Gaylord Community Schools
SF 3.2 NEMSCA Transportation Office
Gaylord, Michigan

October 5, 2020

Project No. 284-20B

ADDENDUM NO. 1

DEMOLITION PLAN
SCALE: 1/4" = 1'-0"

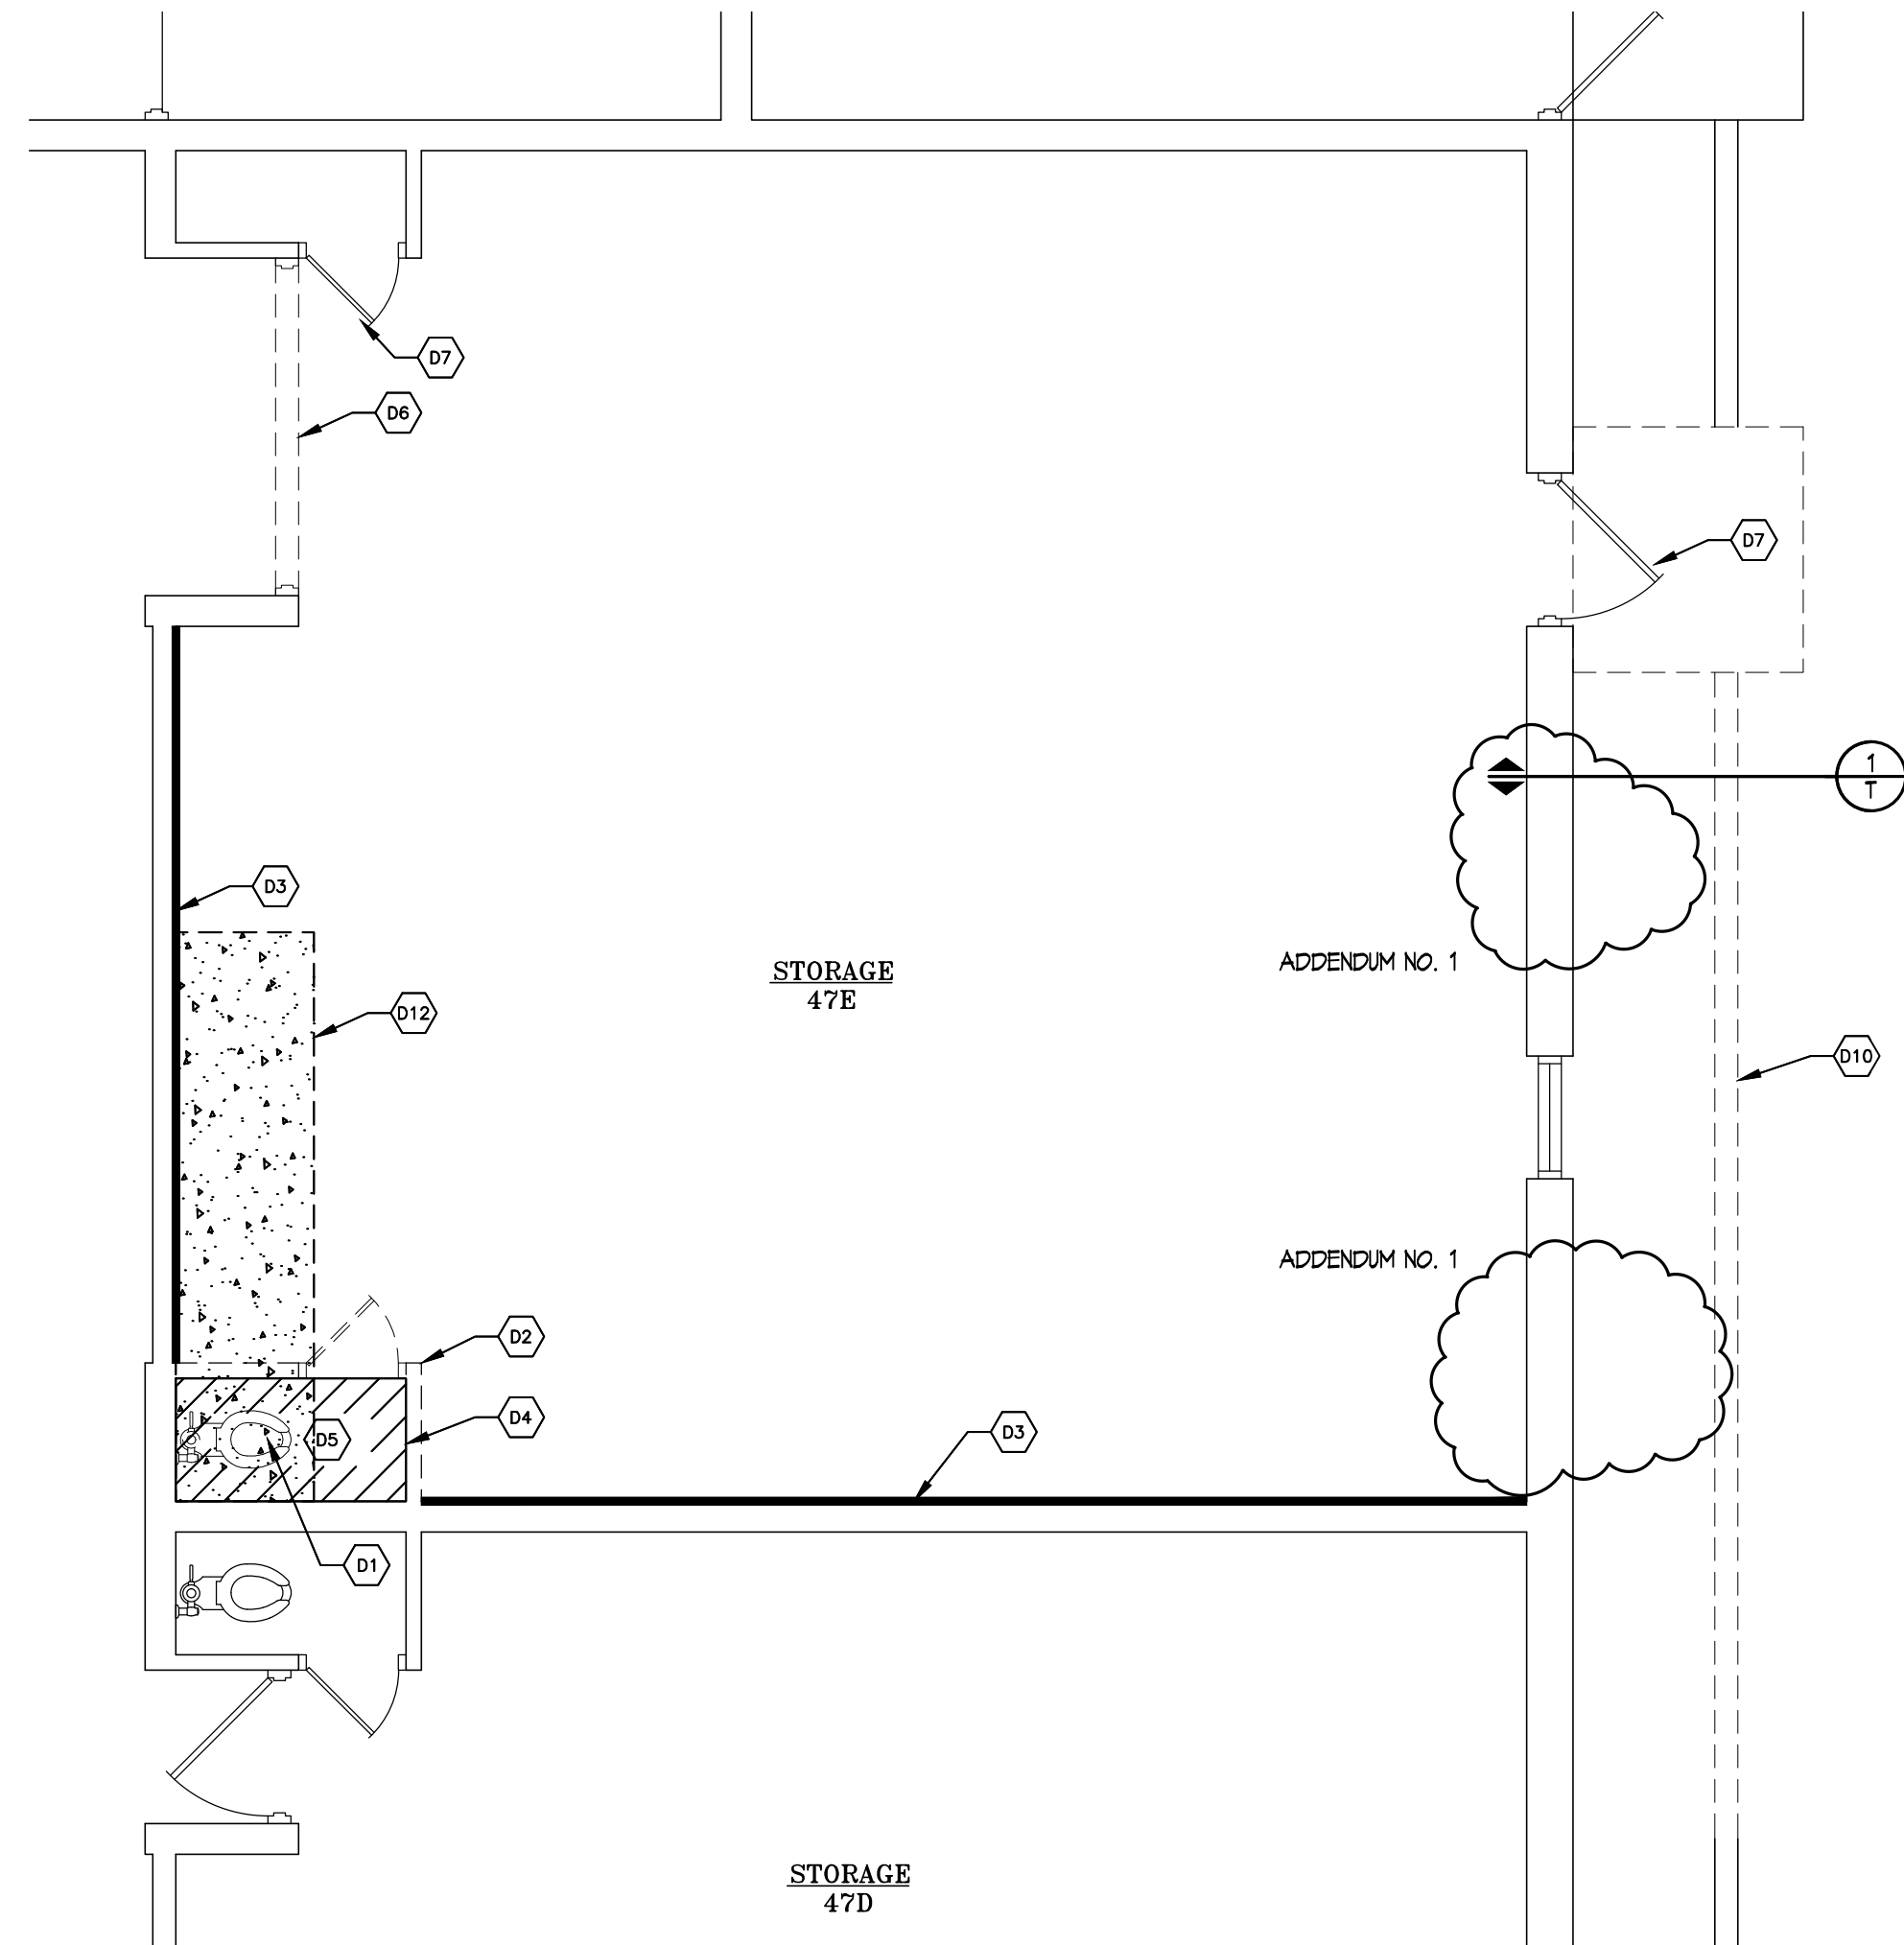
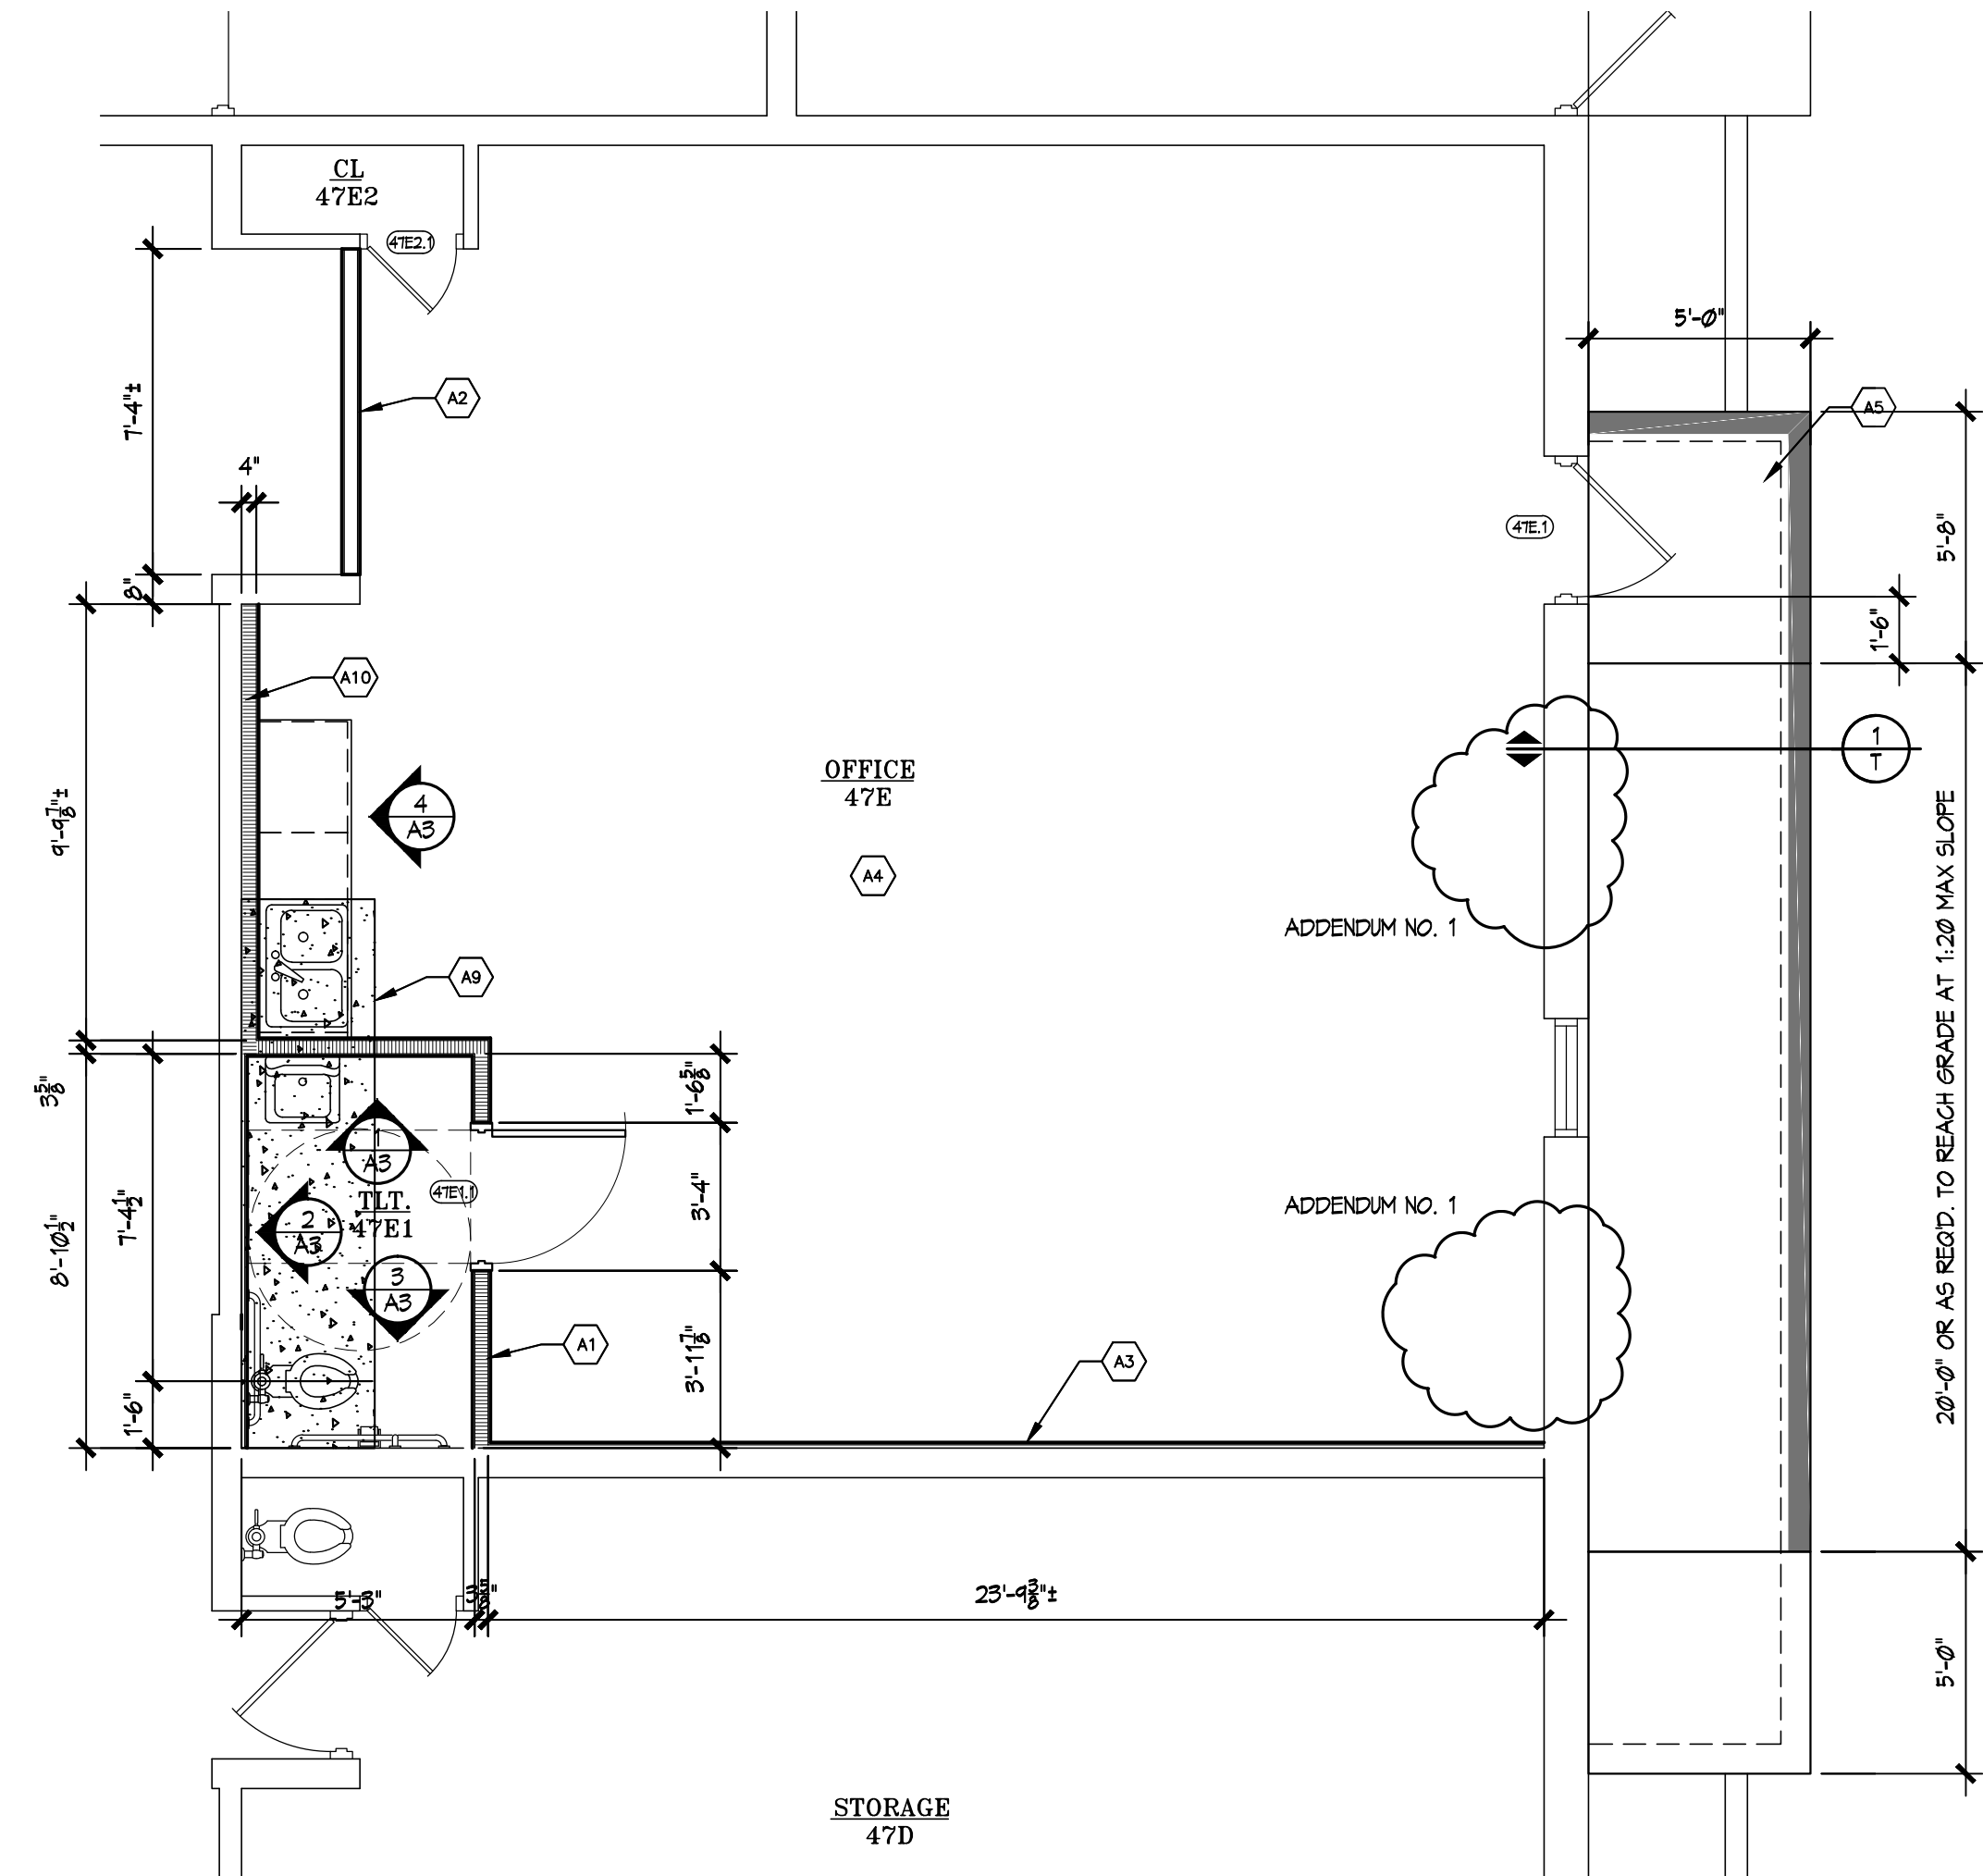
- Item No. 4: Refer to revised drawing sheet A2: Note deletion of Keyed Demolition Tags D11 and Keyed Construction Tags A8 from the respective plans.
- Item No. 5: Refer to revised drawing sheet M1: Note changes in Ductless-Split Air-Source Heat Pump schedule and notes to add Mechanical Support Platform for AHP-TO mounting on roof and also Pipe Portal for refrigerant lines/electrical feeds to/from the AHP-TO and FC-TO.
